Re: Application for Permit # **11-69-0001-P**. Comments of concern regarding permit application for Golden Lotus Dam “permanent drawdown and removal of selected dam infrastructure”.

RE: **Lansing Club Dam Removal**

Figure 2. Reported Sediment Load Compared to Transport Capacity When River Flow is 100 cfs

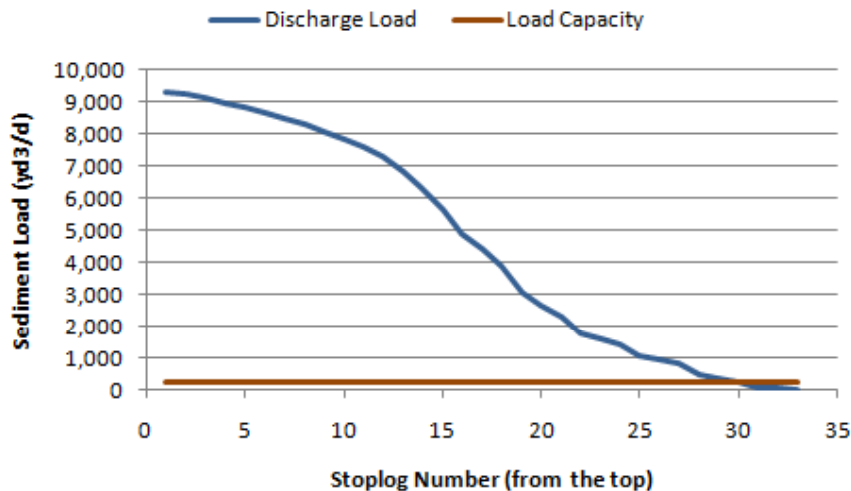
Figure 2 shows that Pigeon River will likely not be capable of transporting the discharge load until nearly 30 stoplogs have been removed. At that point, a total sediment load of 150,490 yd³ will have been released into the stream. At a transport capacity of 243 yd³/d, it would take approximately 620 days to move the sediment through the system.

Figure 3. Sediment Load Assuming 66.6 percent Water Content Compared to Transport Capacity

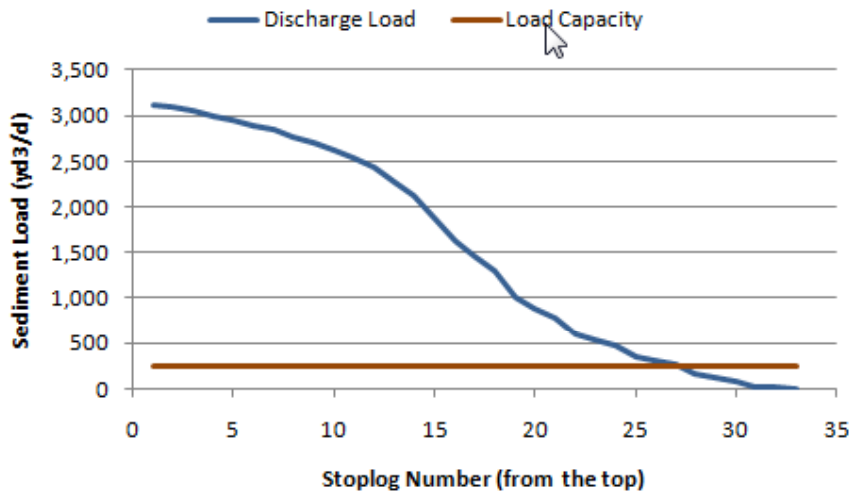
Note that a significant fraction of the discharge load may be water. If we assume that the water content of the sediment that will be discharged is equal to 66.6 percent as shown for sediment sample GL-01 (page 90/134 of the February 2011 Joint Permit Application), the stream is still not capable of transporting the remaining sediment load (Figure 3) until stoplog 28 is removed.

Figure 4. Sediment Load Assuming 95 percent Water Content Compared to Transport Capacity

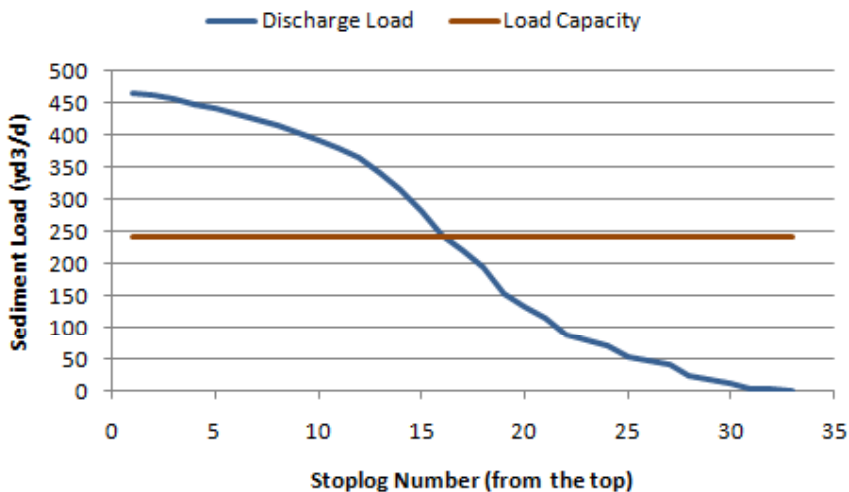
The December 3, 2010, Technical Memorandum states that the average water content of the sediment is 95 percent. The basis of that assumption is not provided. Even if only 5 percent of the discharge load is sediment, the transport capacity is still exceeded for nearly half of the logs removed (Figure 4). Note that as the number of stoplogs removed increases, the water content will decrease and 95 percent water content is likely a high estimate for most of the sediment that has accumulated behind the dam.

Figure 5. Estimated TSS Concentrations in the Material Stored Behind the Dam Relative to Example Background TSS Concentrations

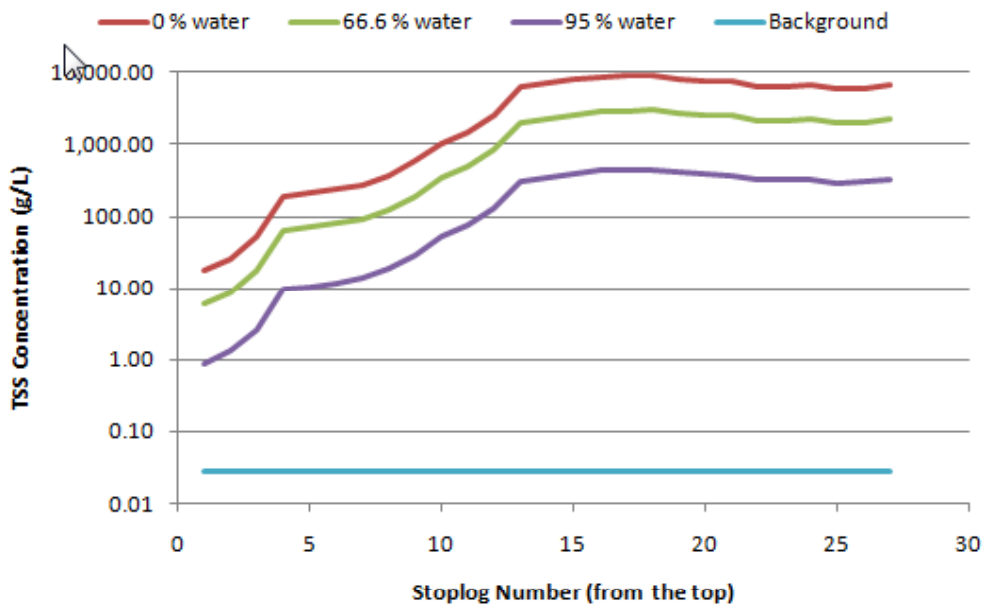
As the number of stoplogs removed increases, the estimated concentrations of the material behind the dam also increase. Figure 5 shows the estimated TSS concentrations for the material in the impoundment, assuming water contents of 0, 66.6, and 95 percent. Volumetric data were only provided through stoplog 27, so this figure does not include data for the remaining stoplogs. According to the USGS Open-File Report 2005-1380 (<http://pubs.usgs.gov/of/2005/1380/pdf/OFR2005-1380.pdf>), average TSS concentration in a river draining a similarly sized watershed is 27 mg/L. The land use in the studied watershed is approximately 75 percent agricultural, so a TSS concentration of 27 mg/L is likely high relative to concentrations present in Pigeon River which drains primarily forest land. As water quality data were not easily accessible for the Pigeon River, a value of 27 mg/L, or 0.027 g/L, provides a comparison to estimated concentrations for the material behind the impoundment (Figure 5). Regardless of assumed water content, the estimated TSS concentration of the material behind the dam is greater than 0.027 g/L.

Figure 6. Estimated TSS Concentrations Following Mixing Relative to Lethal Concentrations

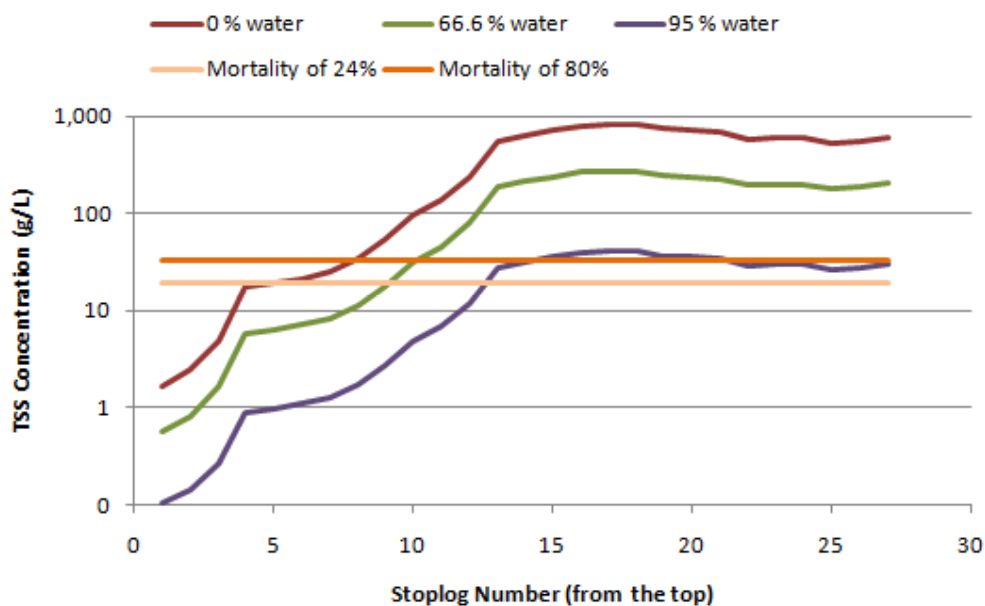
Garric et al. (1990) studied lethal effects of increased TSS and ammonia concentrations and decreased dissolved oxygen levels on brown trout fry. They report that TSS concentrations of 19 and 33 g/L were correlated with 24 and 80 percent mortality, respectively, after 48 hours of exposure. Low DO concentrations (also common following dam removals) increase the lethal effects of TSS so these thresholds may be high.) Figure 6 shows the predicted TSS concentrations for the varying water content assumptions along with the 24 percent and 80 percent mortality concentrations reported by Garric et al. (1990). Each assumption regarding water content will likely result in TSS concentrations greater than the 24 percent mortality threshold following removal of at least half the stoplogs. Assuming a water content of 66.6 to 95 percent water content will likely result in concentrations greater than the 80 percent mortality threshold following removal of approximately two thirds of the stoplogs.
